# Access Compliance Report

## Public Rights-of-Way

| Intersection ID: N/A | Main Street: MAYNARD_RD | Cross Street: MARICOPIA_RIDGE_LN | Location: SW           |
| ADA ID: DC04B3F1BB19 | Ramp Type: Perp         | Initial Pass/Fail: Fail          | Overall Compliance: No |

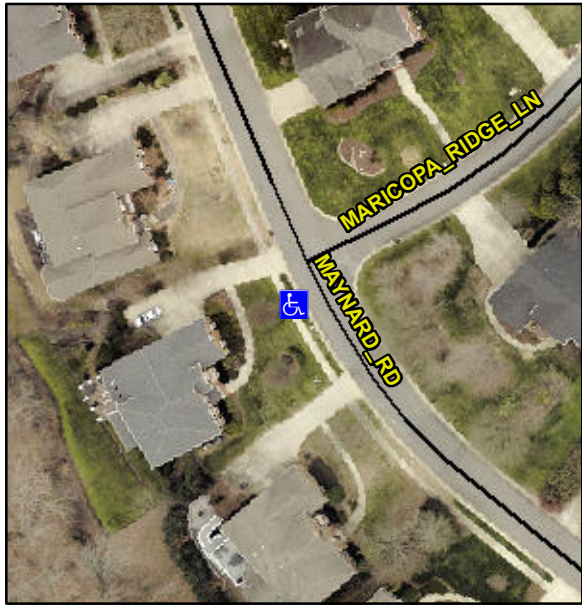
| Codes/Mitigation Info/Possible Solution  |                               |            | Field Measurements/Component Compliance |                       |  |             |  |     |                             |            |      |  |             |  |  |      |
|--|-------------------------------|------------|---|-----------------------|--|-------------|--|-----|-----------------------------|------------|------|--|-------------|--|--|------|
|  |                               |            | No                                      | Ramp Width (in)       |  | 44.3        |  | Yes | Ramp XSlope (%)             |            | 3.3  |  |             |  |  |      |
| PROW/ADA:  |                               | R304.5.1   | N/A                                     | Gutter Ponding?       |  | N/A         |  | N/A | Gutter Slope (%)            |            | N/A  |  |             |  |  |      |

| Codes/Mitigation Info/Possible Solution  |                               |            | Field Measurements/Component Compliance |                       |  |             |  |     |                             |            |      |  |             |  |  |      |
|--|-------------------------------|------------|---|-----------------------|--|-------------|--|-----|-----------------------------|------------|------|--|-------------|--|--|------|
|  | Remove & Replace Entire Ramp. |            | N/A                                     | Ramp Length (in)      |  | 48.0        |  | Yes | Ramp Slope (%)              |            | 5.0  |  |             |  |  |      |
